FINDLAY CITY PLANNING COMMISSION

STAFF REPORT March 11, 2021

3. APPLICATION FOR SITE PLAN REVIEW #SP-08-2021 filed by Findlay Board of Education, 2019 Broad Avenue, Findlay, for a 7,303 square foot modular classroom building to be built at Wilson Vance Elementary School, 610 Bristol Drive, and a 6,644 square foot modular classroom building to be built at Bigelow Hill Elementary School, 300 Hillcrest Avenue.

SP-08-2021

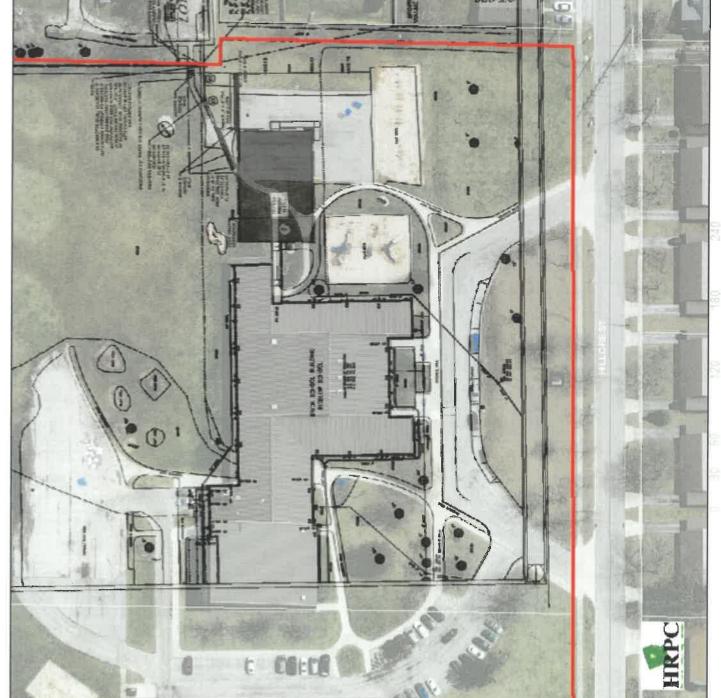
There appears to be some wall pack lighting on the structure. We would request assurance from the applicant that lighting will be shielded from the neighbors to the north. The existing play area will be removed, which will require them to relocate two (2) basketball poles and two (2) evergreen trees. They will be adding an additional 4,437 sf asphalt play pavement area to the north of the building. Although there are no landscaping requirements in the R-1 zoning district, landscaping would be appropriate to buffer the neighbors to the north. A detention basin will be added between the existing building and the modular building. A new hydrant will be installed on the existing waterline.

There appears to be some wall pack lighting on the structure. We would request assurance from the applicant that lighting will be shielded from the neighbors to the east. Although there are no landscaping requirements in the R-1 zoning district, landscaping would be appropriate to buffer the neighbors to the east. Part of the play area will be removed, which will require them to relocate two (2) basketball poles, a tetherball pole, and two (2) benches.

Utilities – No concerns with the proposed utilities on either site. The proposed water meters will need to be placed in the street right of way in a grass area.
